**DOWNTOWN DEVELOPMENT AUTHORITY SPECIAL MEETING AGENDA  
JONESVILLE CITY HALL - 265 E. CHICAGO STREET - JONESVILLE, MI  
DECEMBER 17, 2024, 8:30 A.M.**

**7. A. Chicago Street Road Diet and Streetscape Plans** **[Action]**

<b>MICHIGAN DEPARTMENT OF TRANSPORTATION</b> BRADLEY C. WIEFERICH, P.E. - DIRECTOR	
MILES:	
CONTRACT FOR:	
US-12 & M-99	DRAWING SHEET
FAYETTE TOWNSHIP	US12 SECT 1
HILLSDALE COUNTY	TITLE 001
	1

**From:** Jeff Gray  
**Sent:** Thursday, December 12, 2024 11:13 AM  
**To:** Larry Hummel  
**Cc:** Lamb, Veronica (MDOT); Bob W. Dolweck; Aman Golshan  
**Subject:** RE: 213389 US12 - Jonesville Plans for DDA Review

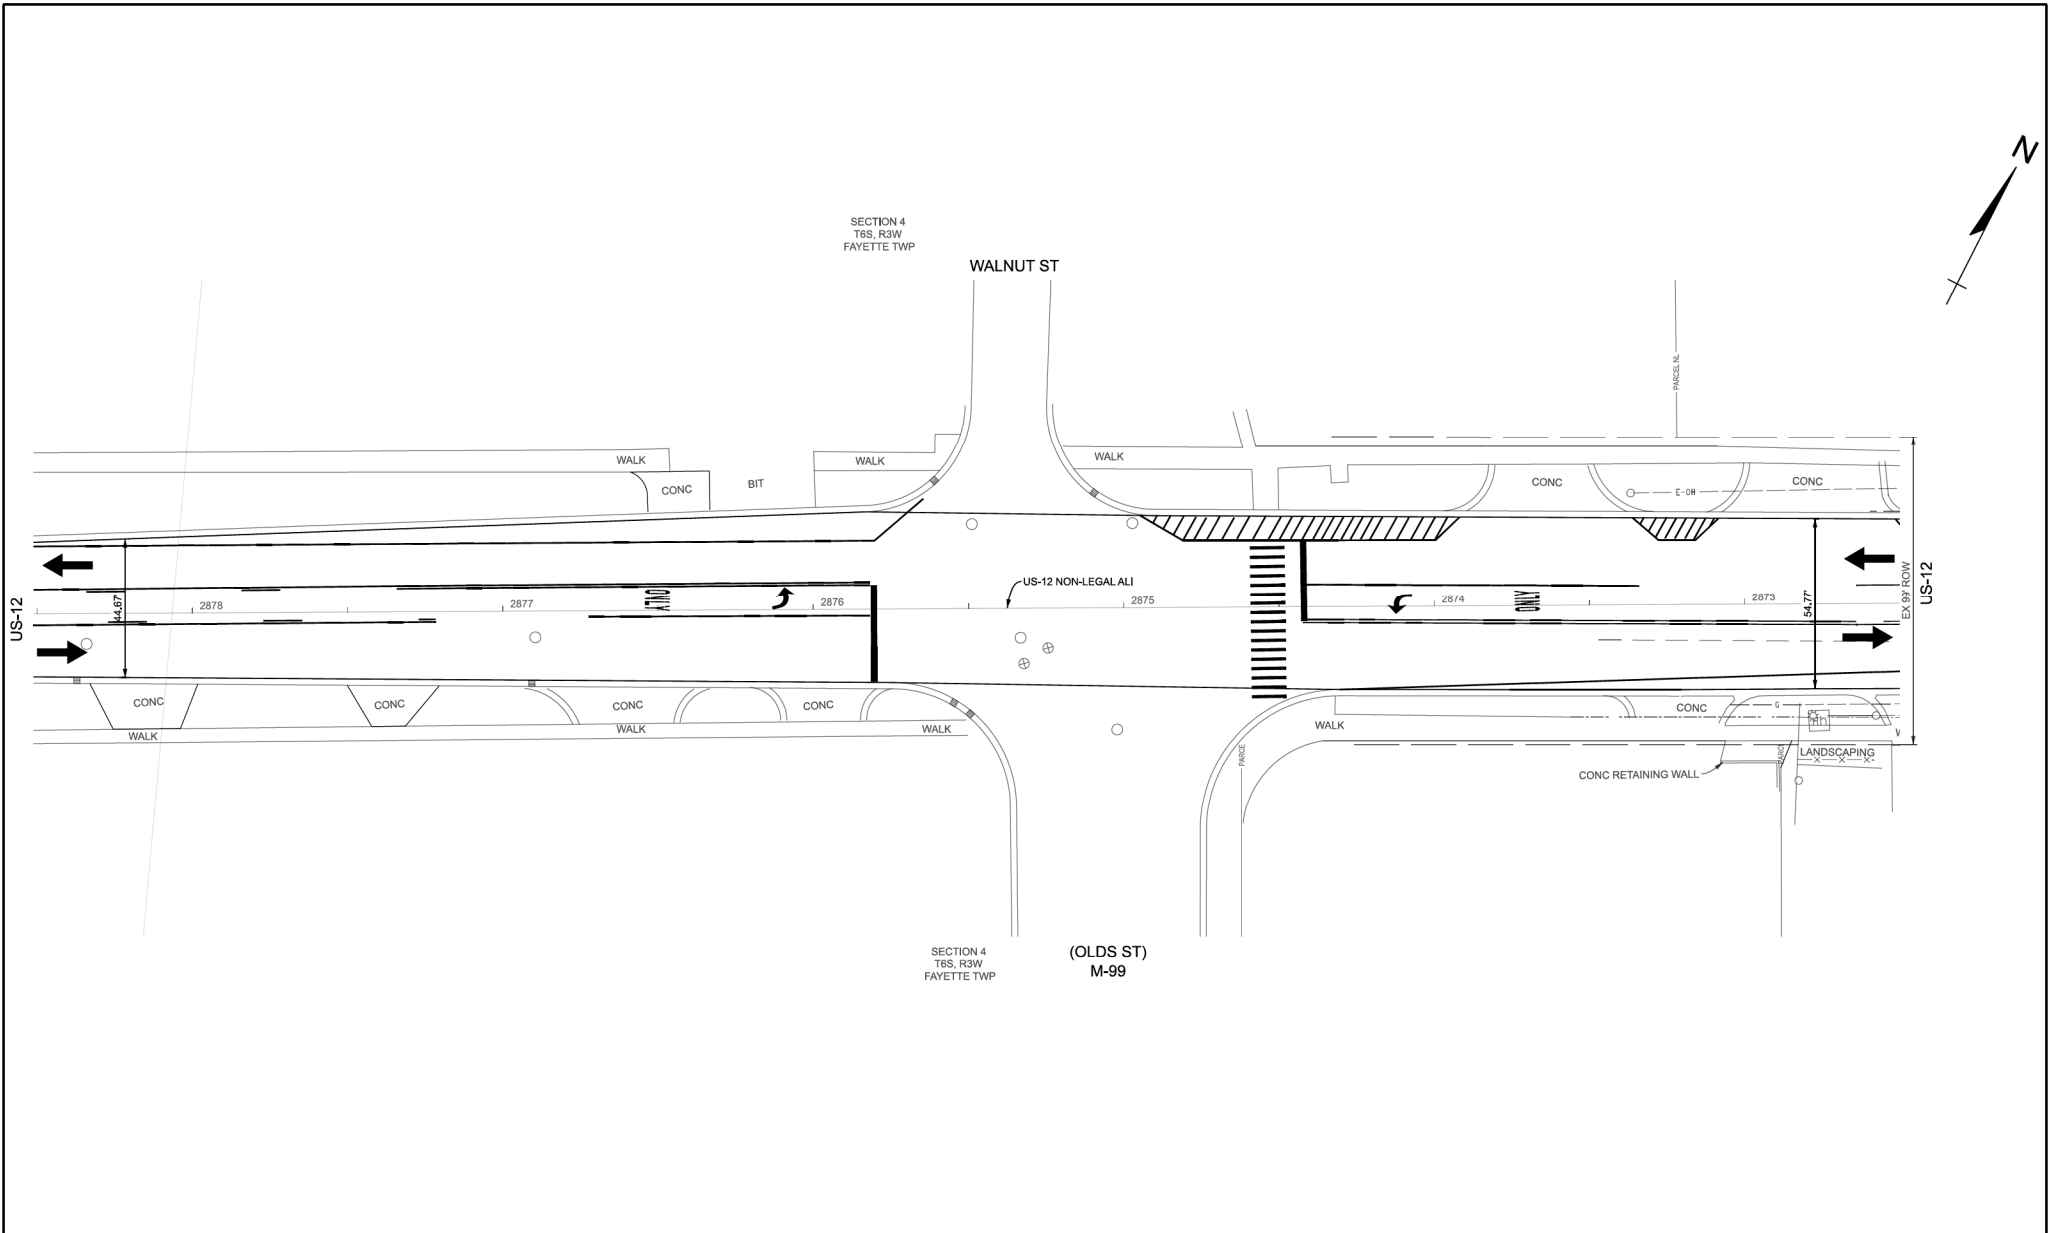
- The City is referred to as the "Village of Jonesville" on the cover and a few spots throughout. Could that be updated to City of Jonesville?
- Property owner information on pages 35 and 36 does not appear to be current.

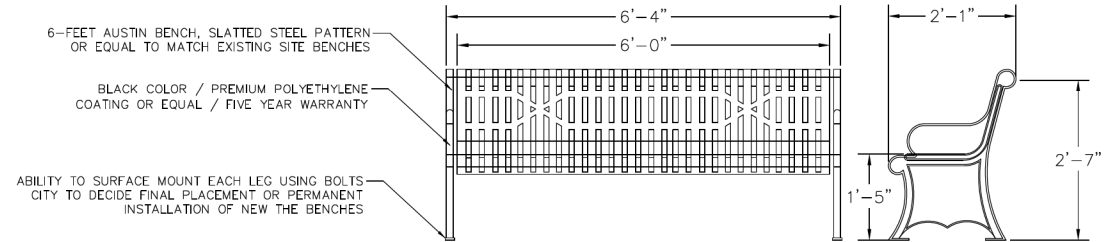
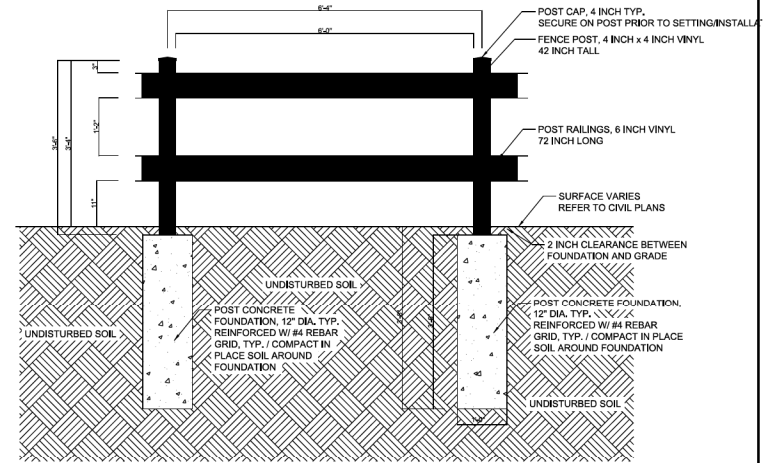
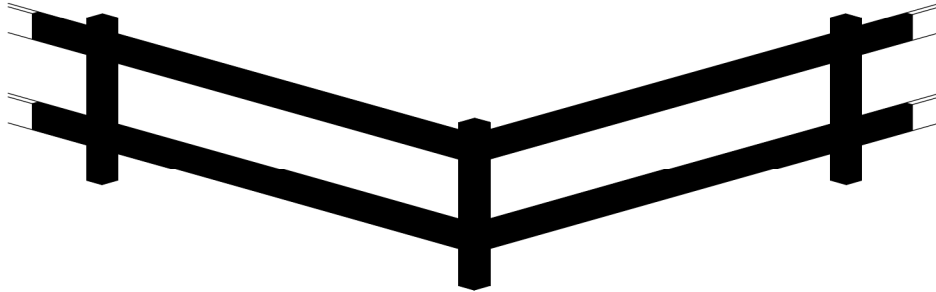
- I have a few questions related to the trailhead work:
  - I found the detail illustrations of the bike repair station and the fencing on the last few pages of the plan set. However, I don't see them depicted on the plan view on page 63. Is that design still to be determined?

## COLORED CONCRETE OPTIONS AND PATTERNS

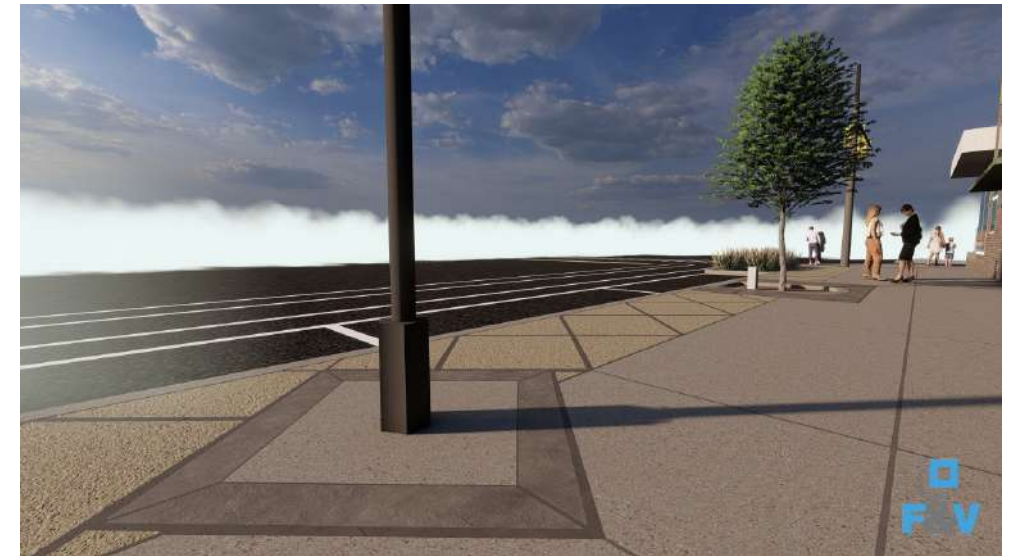
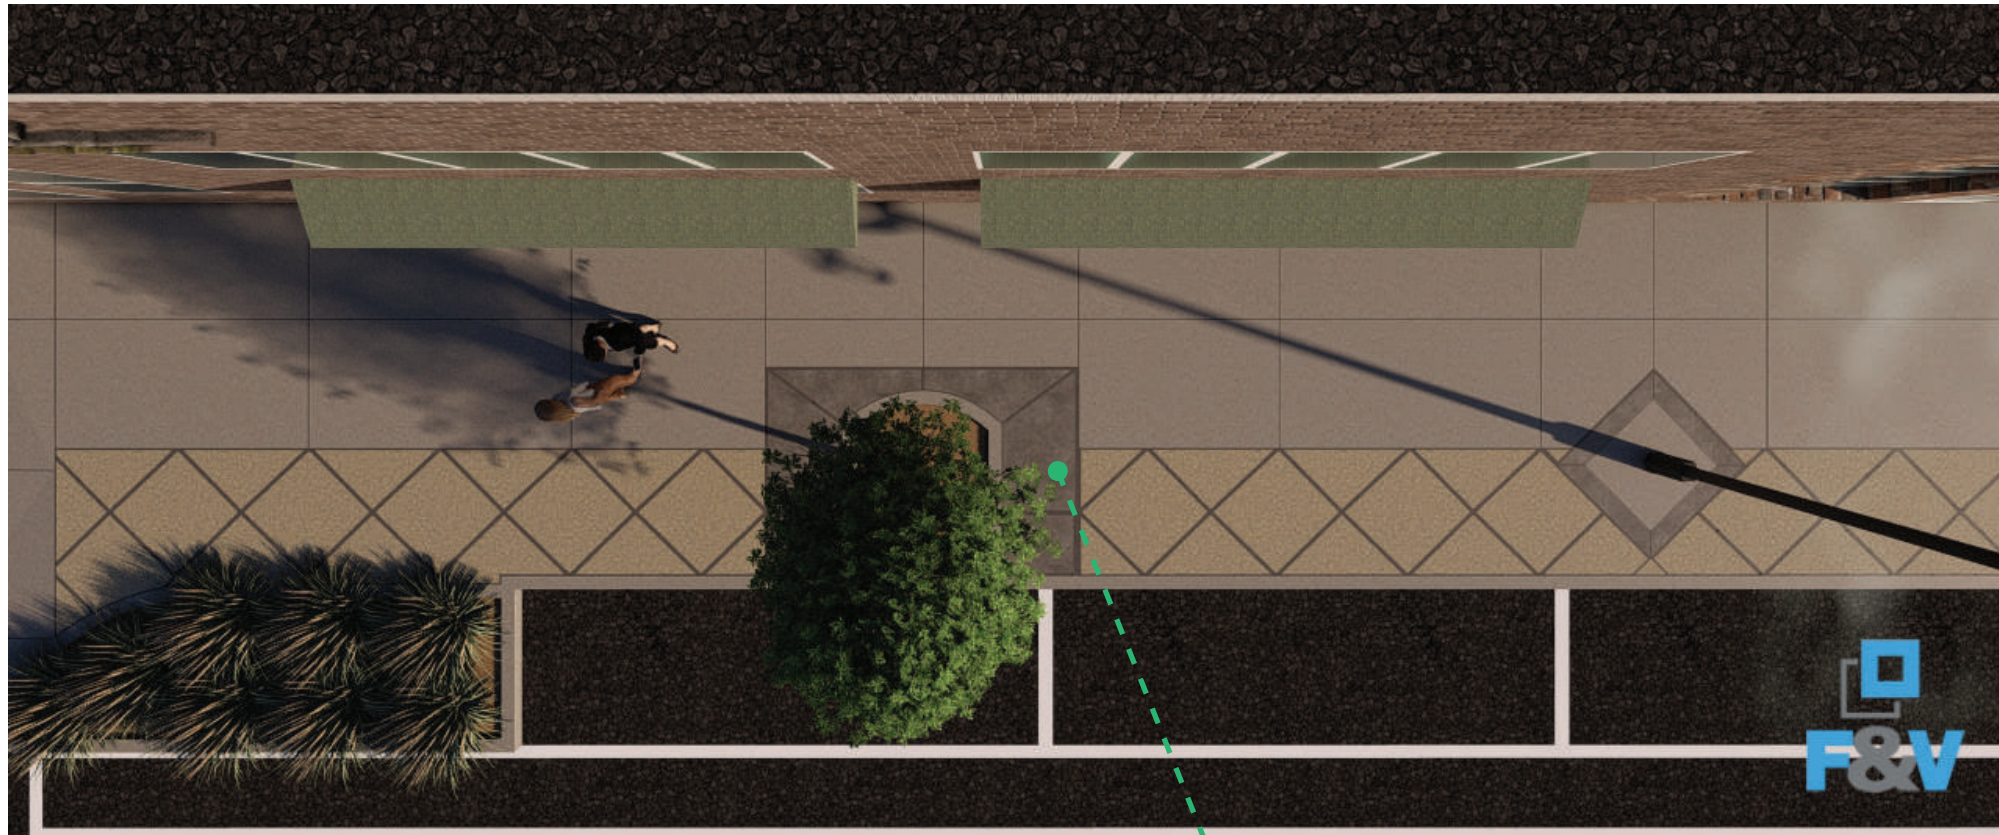
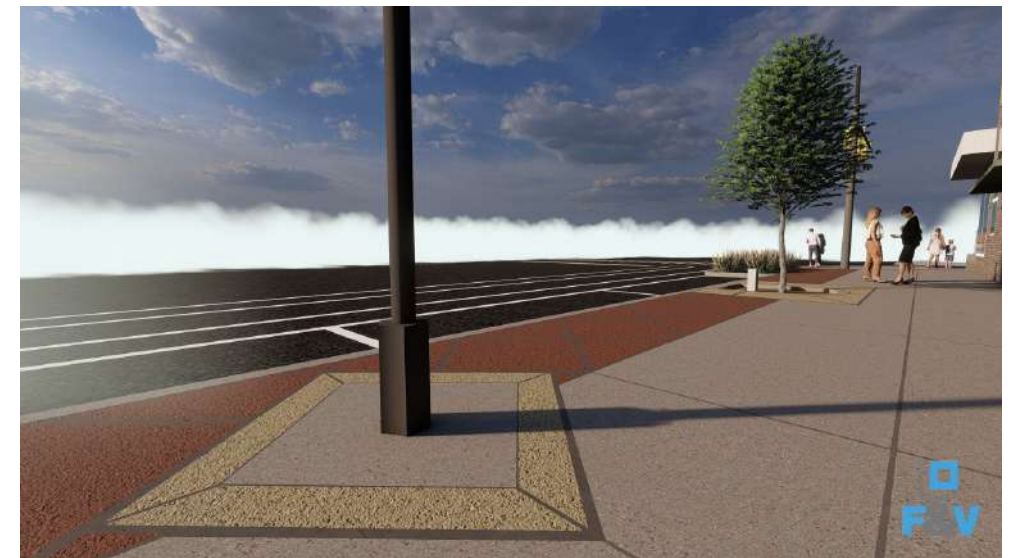
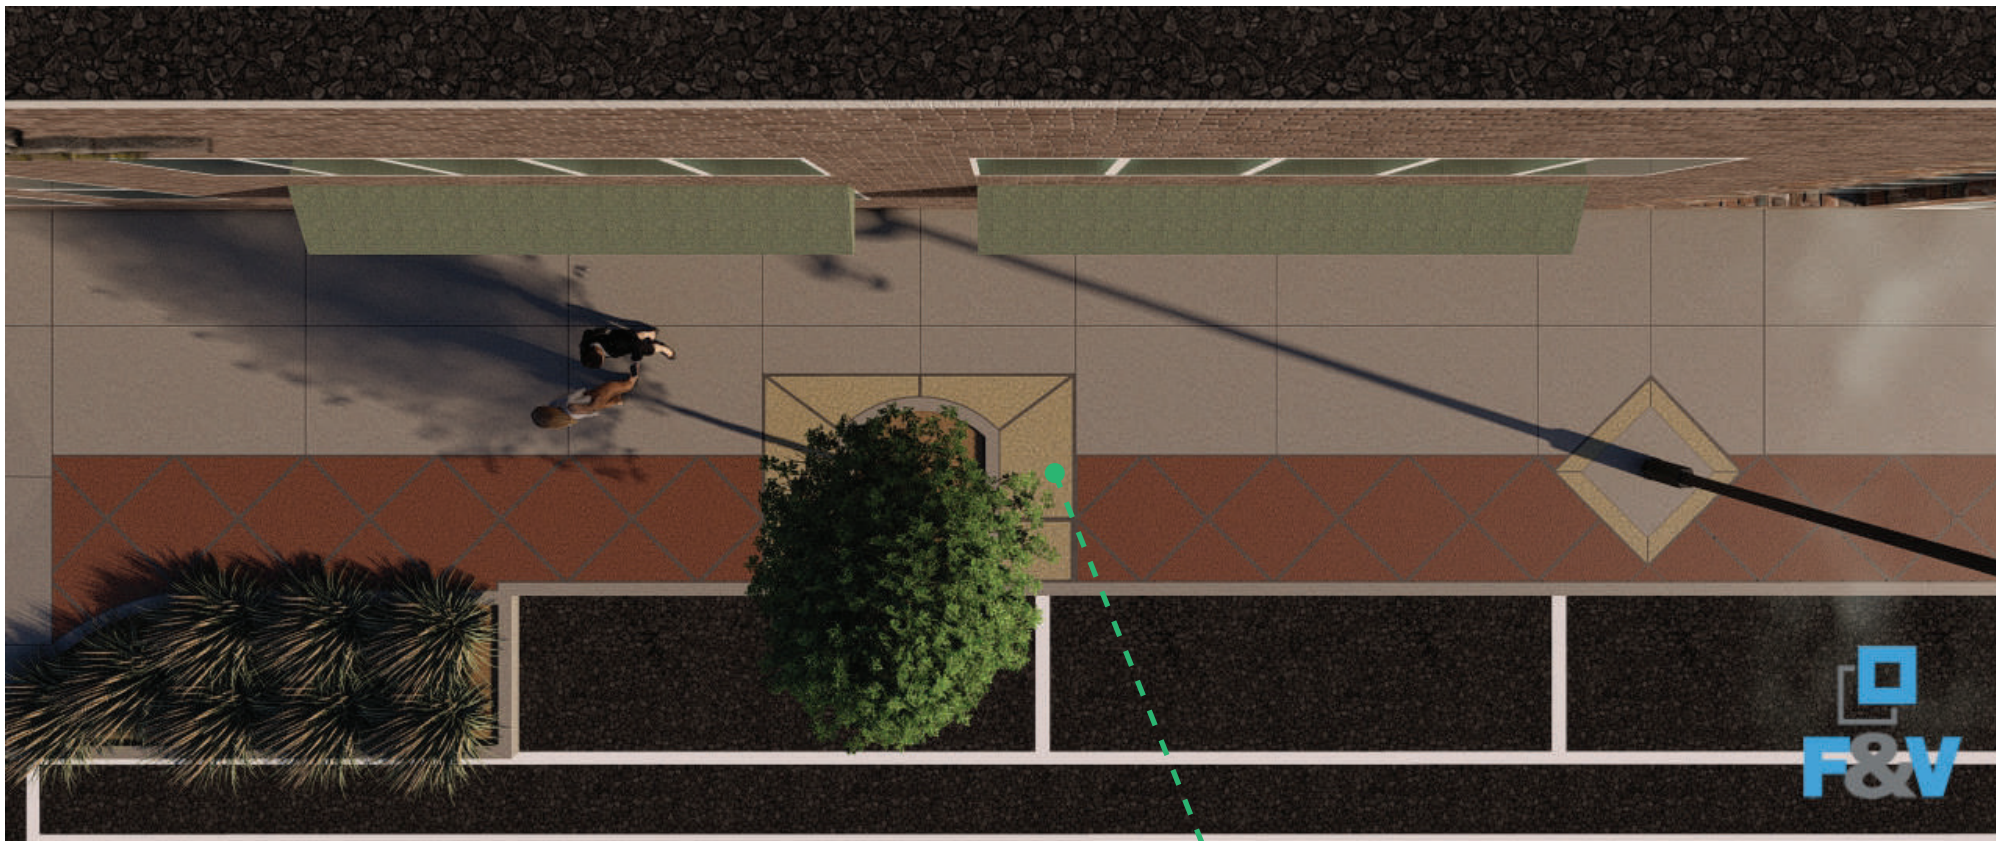
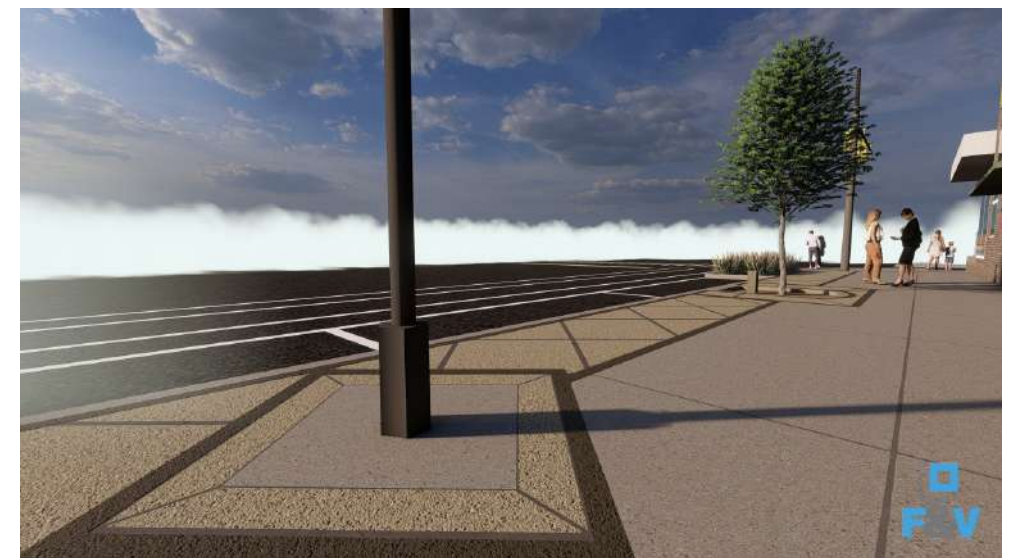
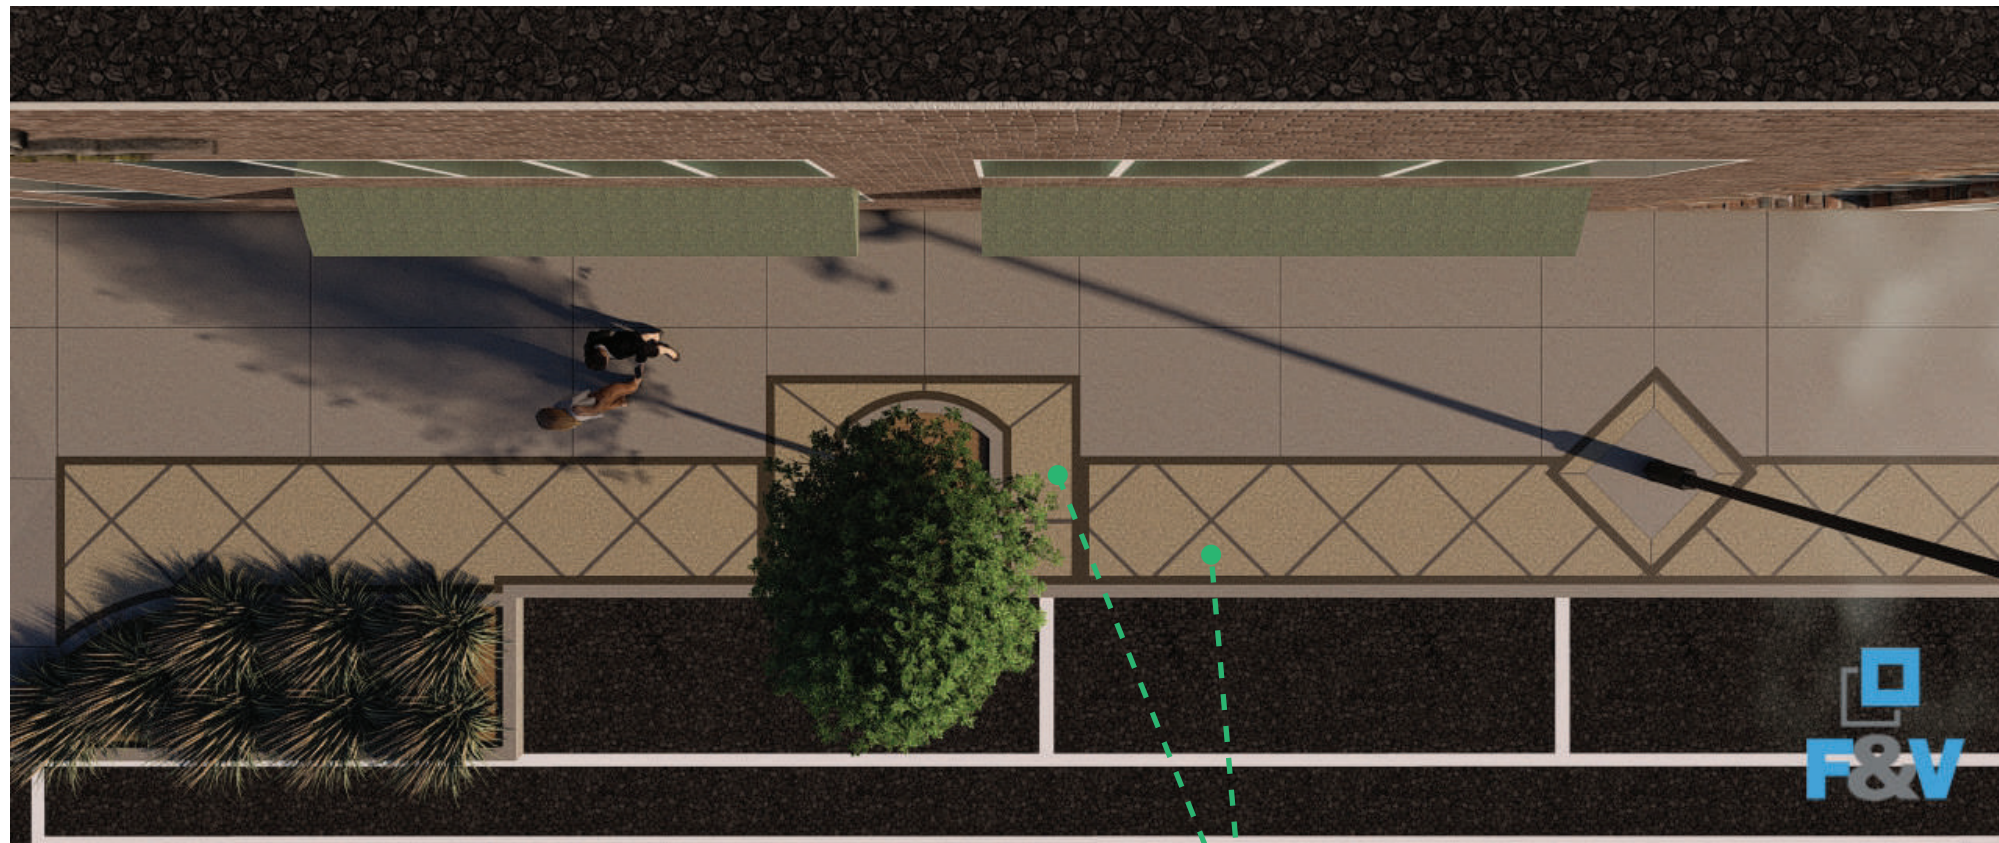
- The tree wells are depicted on the concrete illustrations. Are those depictions accurate in terms of how those wells will be designed in terms of the fill material and the new receptacles? I like how the details of the design and location of the outlets and the rubberized covering are depicted in the illustration, but want to be clear as to whether that is an artistic rendering or a depiction of the planned design.
